### COLLEX464InventoryMarkedPlan

# CARDINAL

### CARDINAL REVISION LIST - STRUCTURAL:

## CARDINAL REVISION LIST - ARCHITECTURAL:

#### CHANGES ON 10-01-22

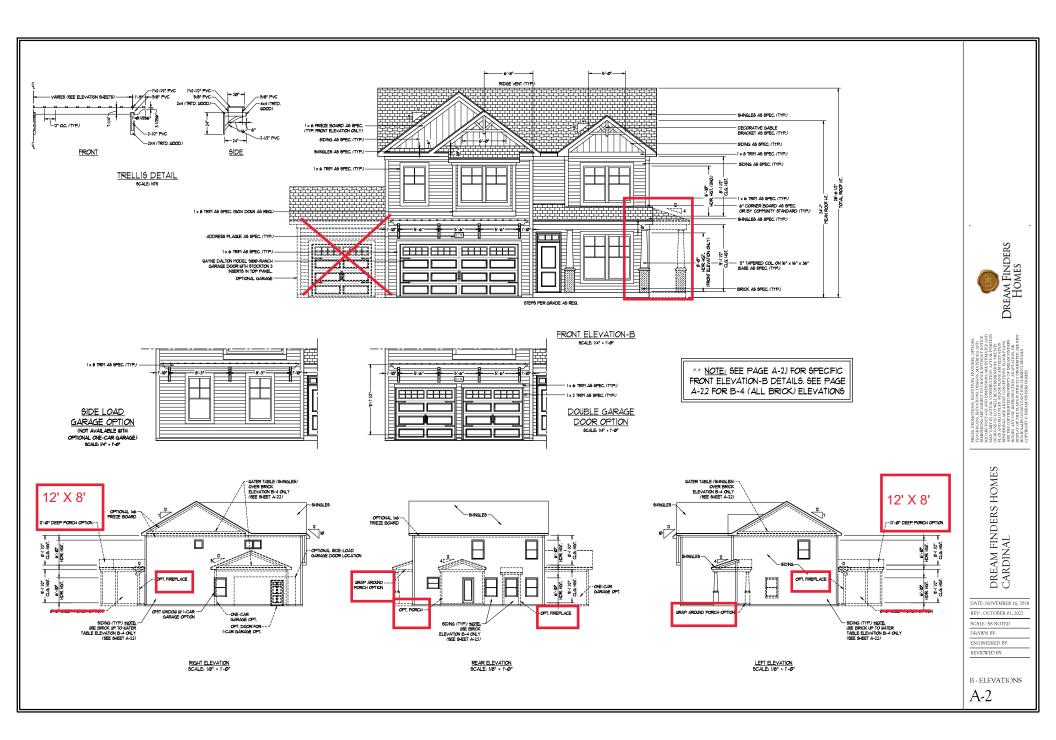
- 12. ADDED OPTIONAL 3/0 5/0 WINDOW TO SIDE OF HOUSE IN DINING ROOM
- 13. ADDED OPTIONAL DOUBLE OVEN TO KITCHEN FOR "GOURMET KITCHEN"

- 14. REMOVE CLOSET FROM FOYER
- 15. ROTATE POWDER AND PANTRY
- 16. MOVE DOOR IN KITCHEN, REMOVE ADJACENT 3/0 x 3/0 WINDOW
- 17. EXTEND THE KITCHEN COUNTERTOP AND LARGER ISLAND OPTION
